ADDENDUM

NO. 01

PROJECT NAME: Littleton Springs Elementary School

ADDENDUM DATE: March 13, 2026

Job No. 1974-03-01
Drawn By: KLK
Date: 03/03/2026
Sheet No. AS1.02

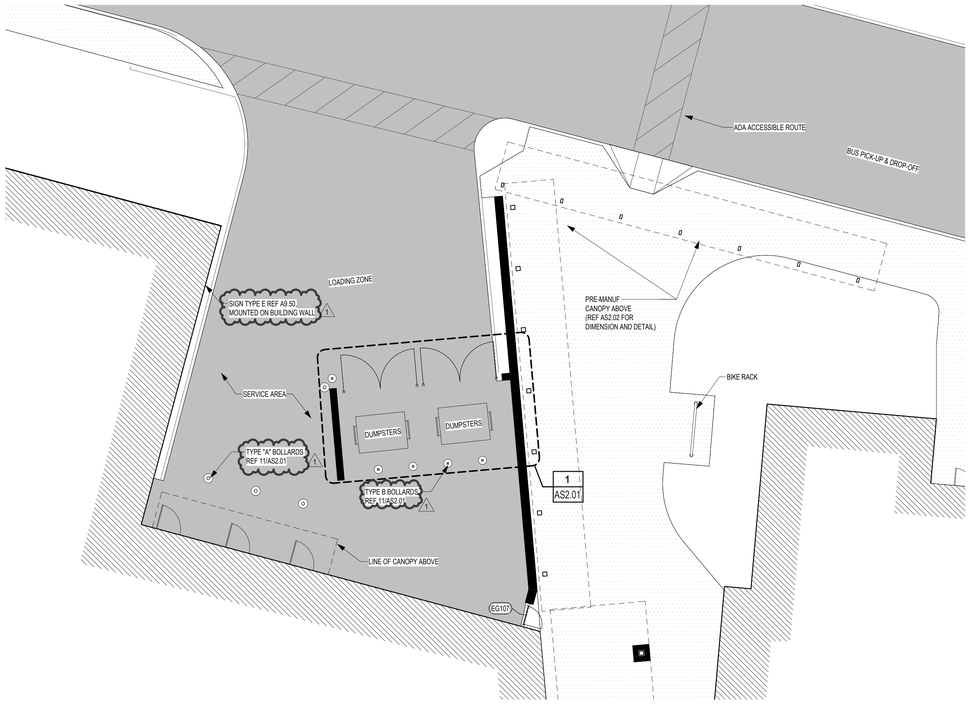
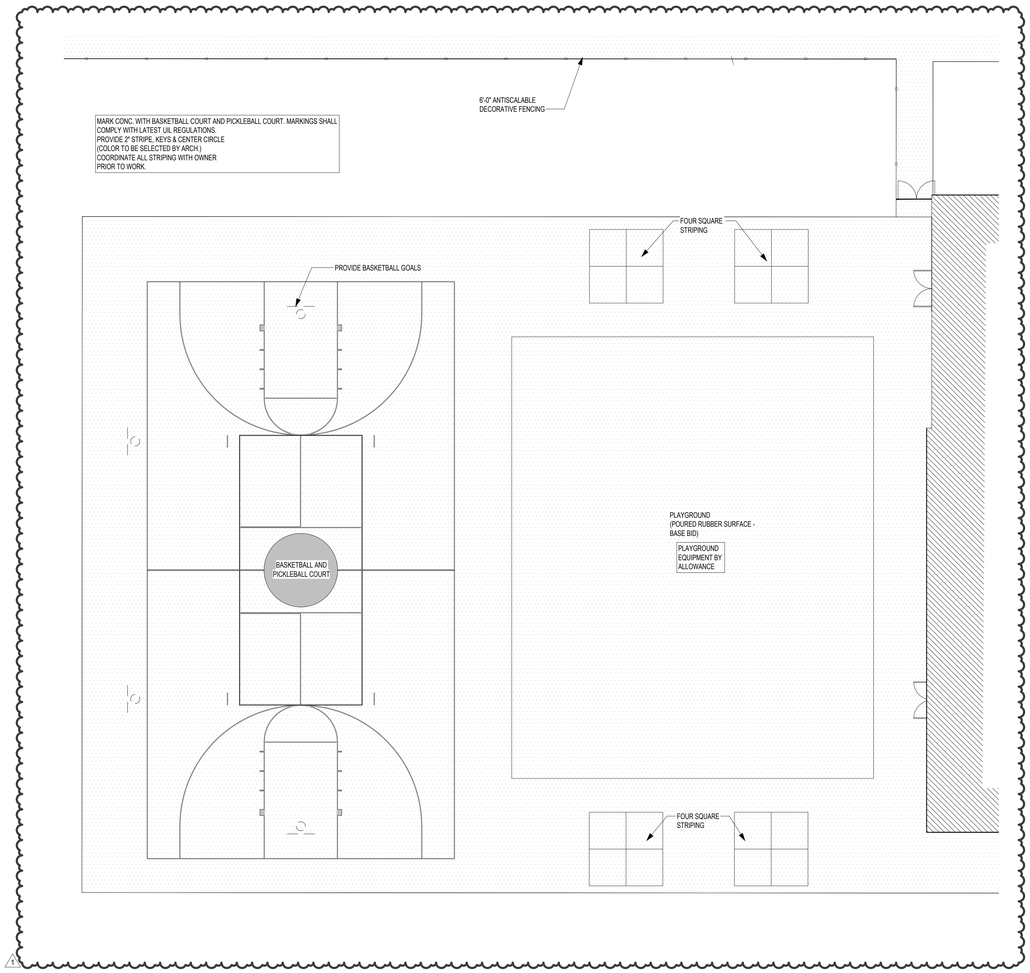
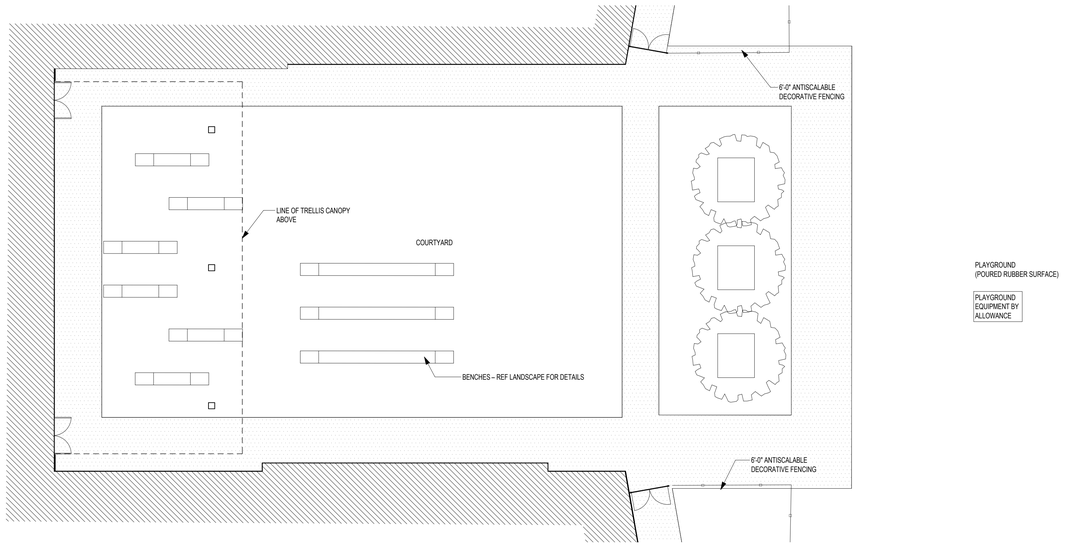
P2ADD 01, Arch Item 9: To the Drawings, Sheet AS1.02 "ENLARGED ARCHITECTURAL SITE PLANS"
Replace sheet in its entirety as issued per this Addendum, Revisions as follows:
1) Revise text note to include pickleball stripping at plan view 02/AS1.02
2) Pickleball stripping added to basketball court on detail 02/AS1.02
3) For clarity, text notes revised 03/AS1.02

Job No.	Sheet No.
1974-03-01	AS2.00
Drawn By: GF, HC	
Date: 03/02/2026

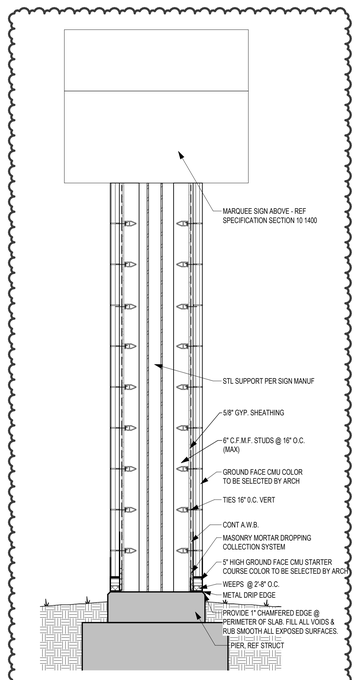
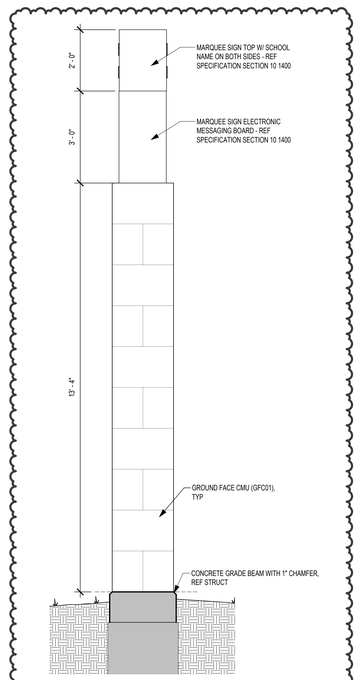
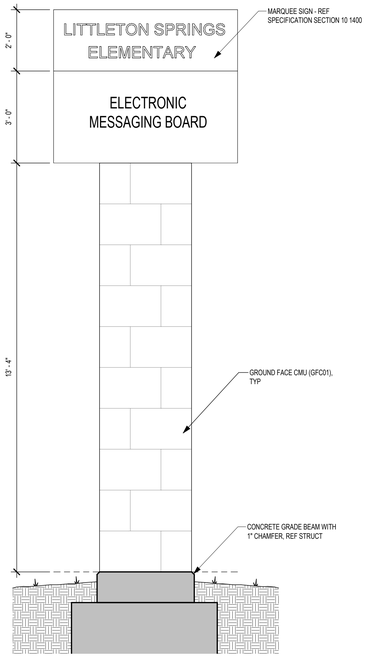
P2ADD 01, Arch Item 10: To the Drawings, Sheet AS2.00, "SITE SIGN DETAILS"
Replace sheet in its entirety as issued per this Addendum, Revisions as follows:
1) Detail information added to marquee sign plan detail 01
2) Elevation 03 added
3) Detail information added to marquee section 04
4) Views reorganized and renumbered

01 MASTER PLAN - LEVEL 01
1/16" = 1'-0"

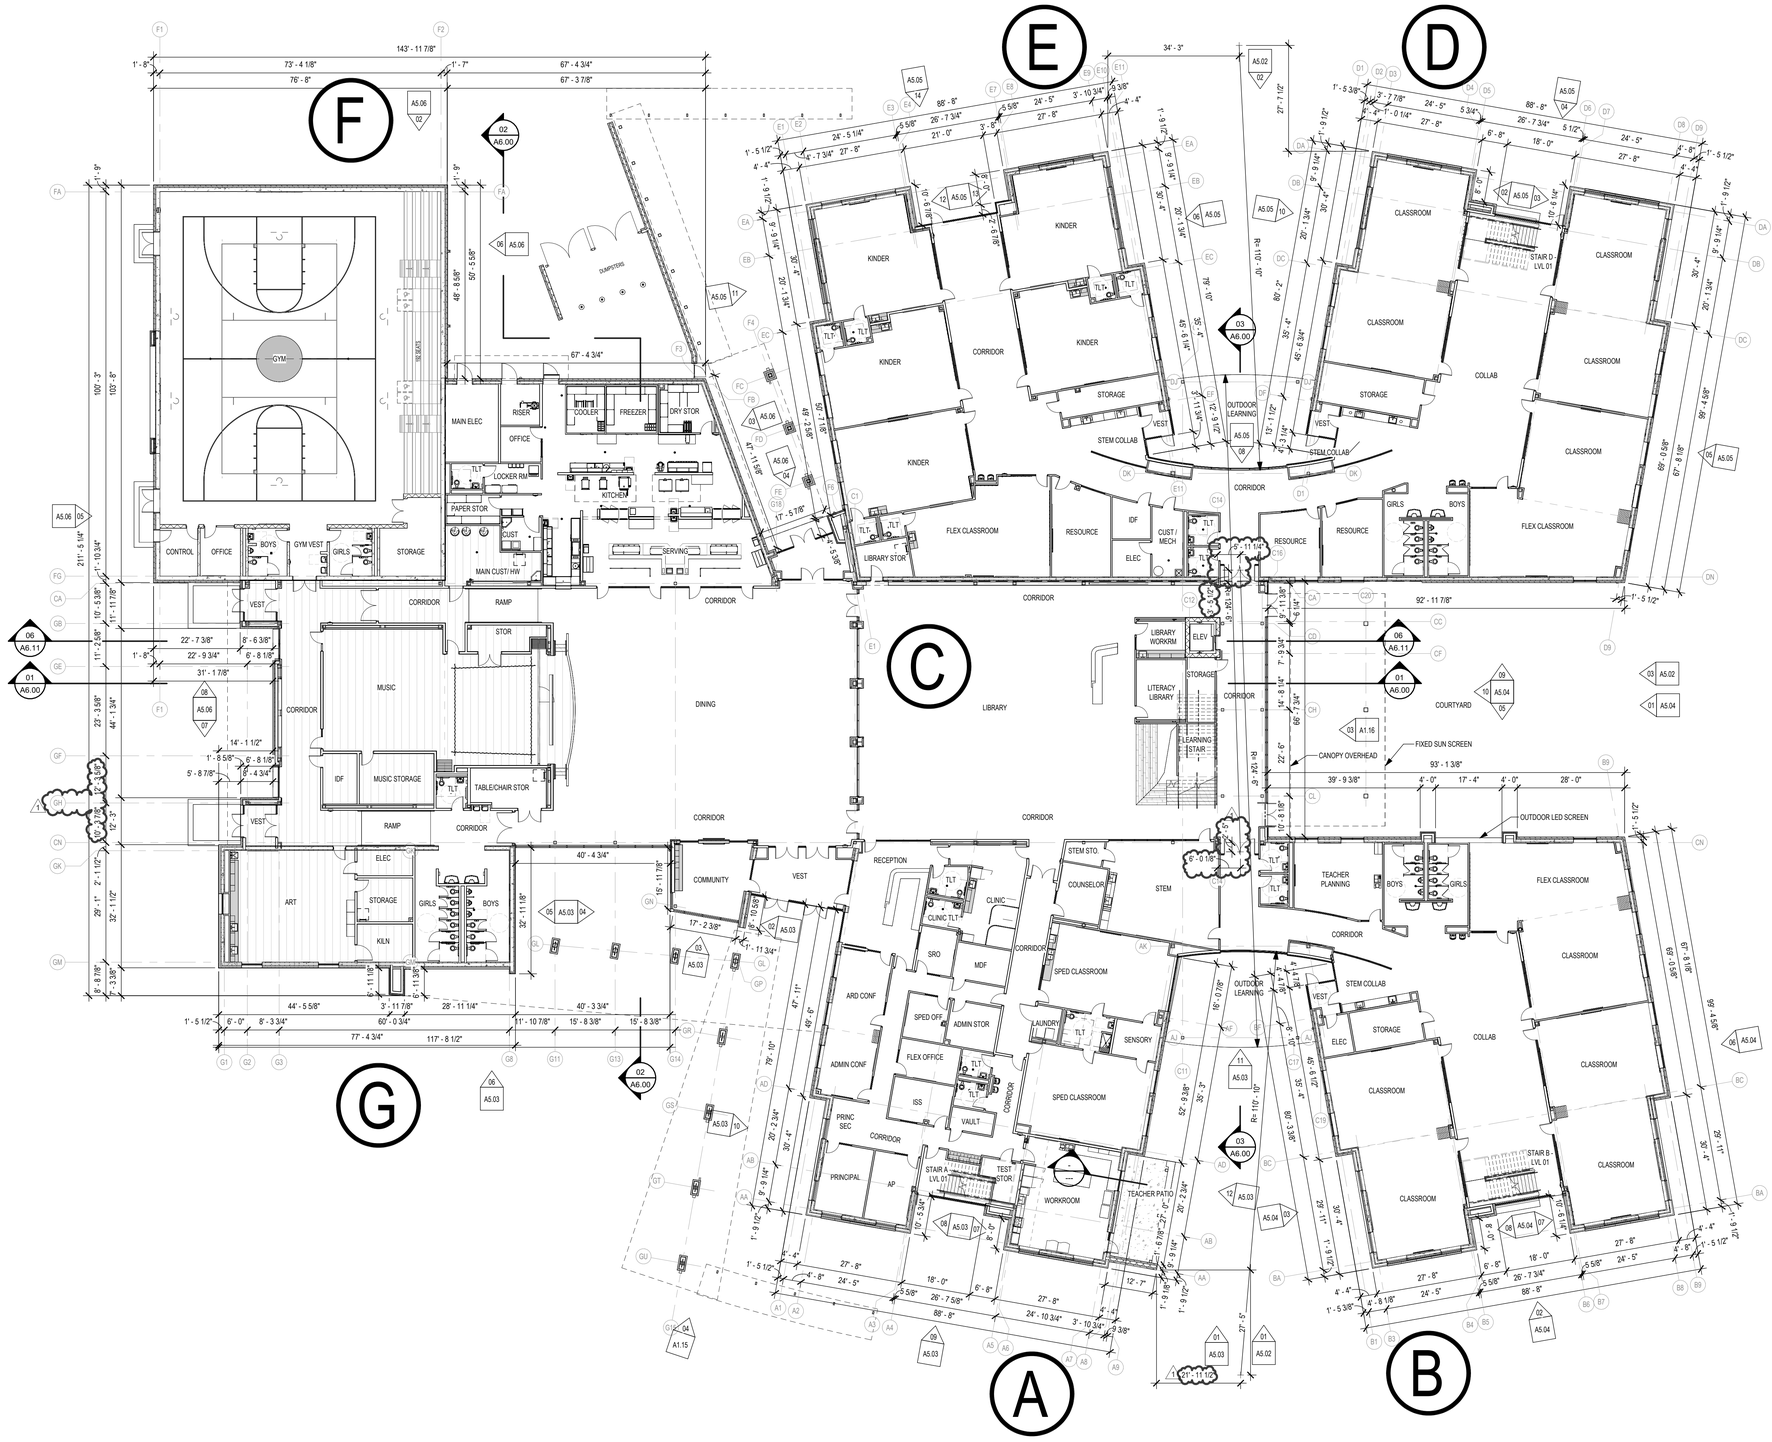
P2ADD 01, Arch Item 11: To the Drawings, Sheet A0.01, "MASTER PLAN – LEVEL 01,"
Replace sheet in its entirety as issued per this Addendum, Revisions as follows:
1) Column Grid GH moved 1" to align with structure column grid

01 FLOOR PLAN - AREA F - LEVEL 01
1/8" = 1'-0"

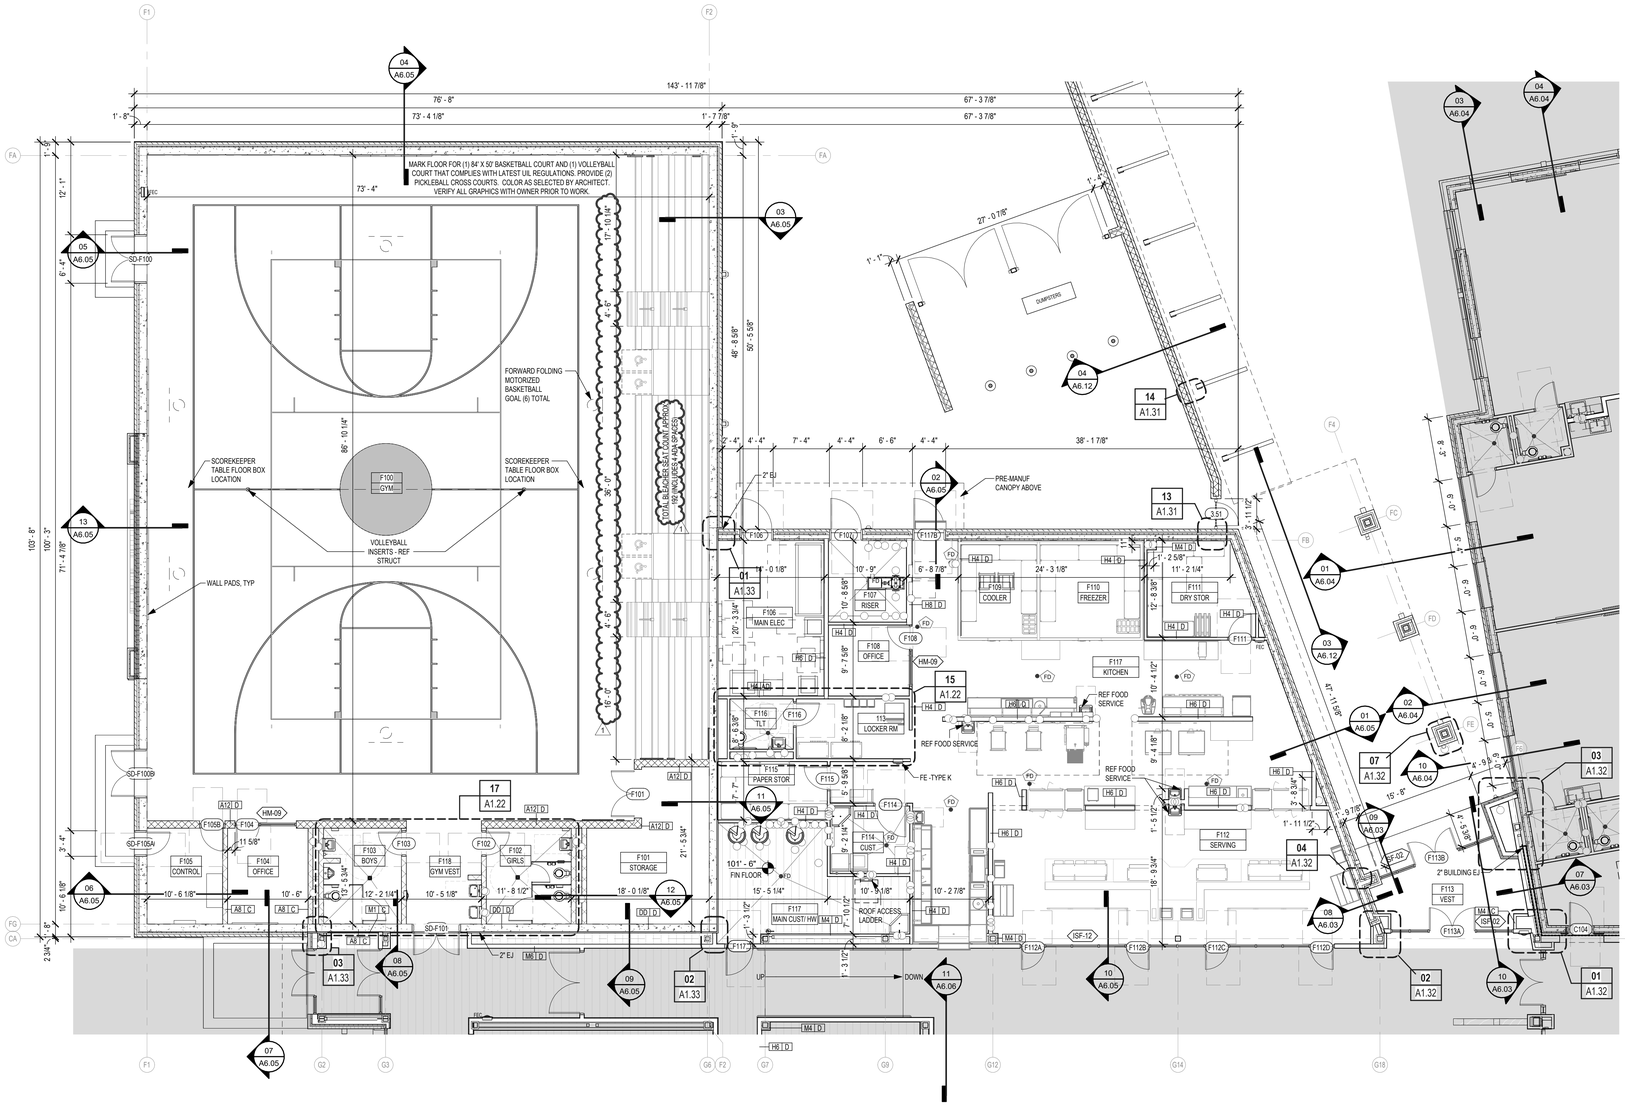
P2ADD 01, Arch Item 12: To the Drawings, Sheet A1.06, "FLOOR PLAN – AREA F – LEVEL 01,"
Replace sheet in its entirety as issued per this Addendum, Revisions as follows:
1) For clarity, Bleacher note and dimensions revised

01 FLOOR PLAN - AREA G - LEVEL 01
1/8" = 1'-0"

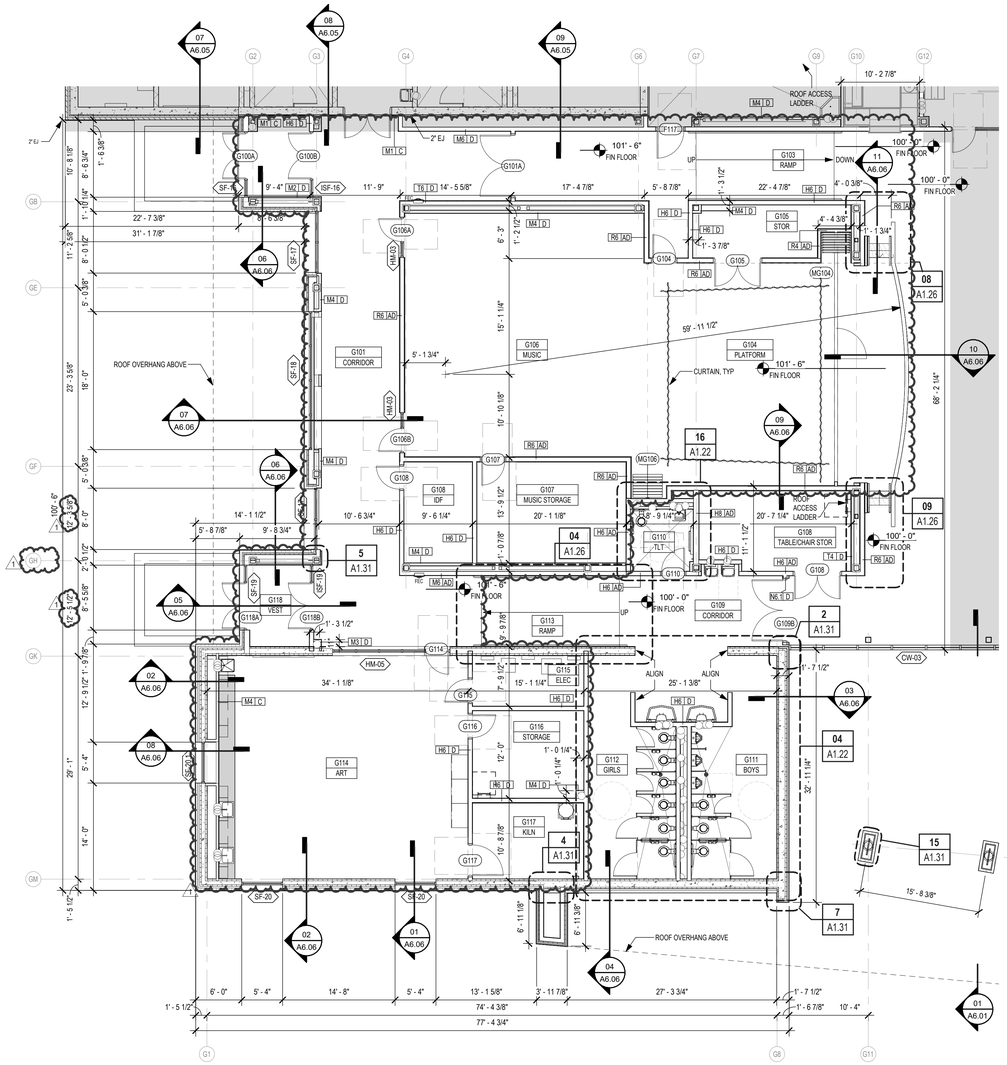
P2ADD 01, Arch Item 13: To the Drawings, Sheet A1.07, "FLOOR PLAN - AREA G - LEVEL 01 ,"
Replace sheet in its entirety as issued per this Addendum, Revisions as follows:
1) Column Grid GH moved 1" to align with structure column grid
2) For Clarity floor pattern removed

01 MASTER REFLECTED CEILING PLAN - LEVEL 01
1/16" = 1'-0"

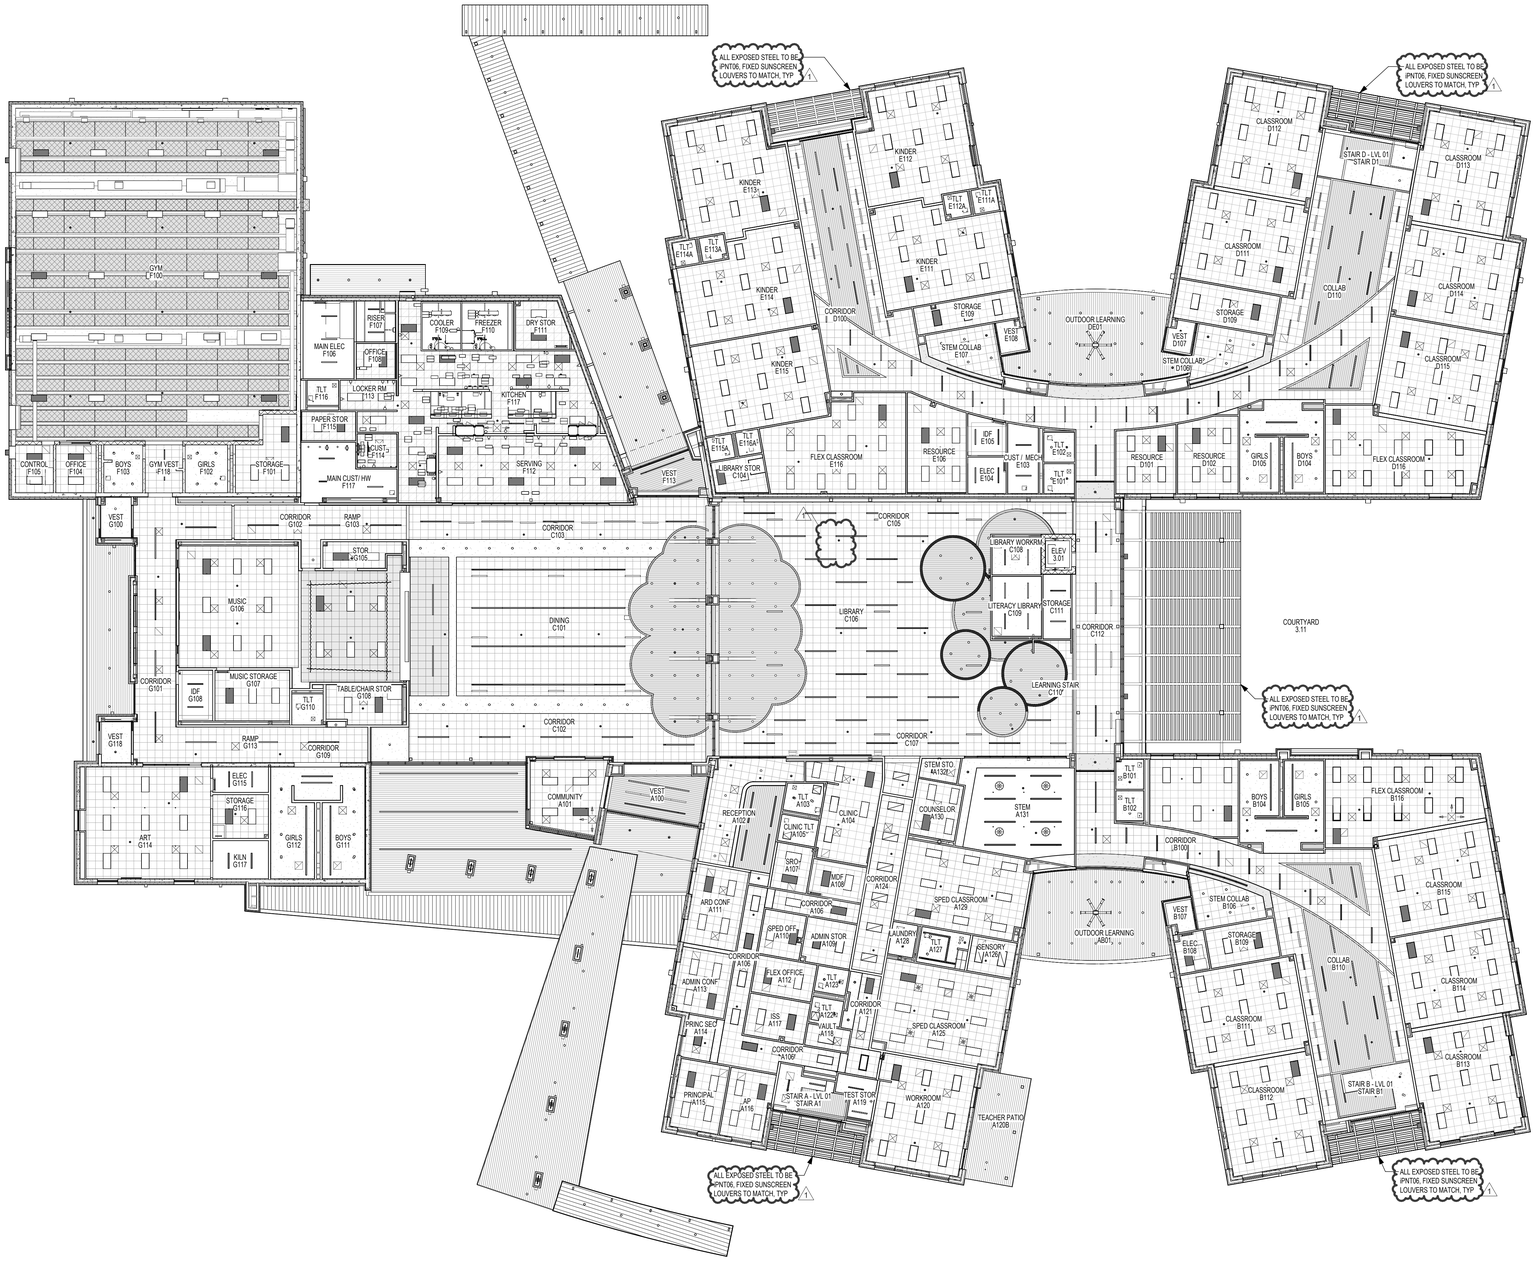
P2ADD 01, Arch Item 14: To the Drawings, Sheet A200.1 , "MASTER REFLECTED CEILING PLAN - LEVEL 01 ,"
Replace sheet in its entirety as issued per this Addendum, Revisions as follows:
1) Finish notes added to all Fixed sun screens
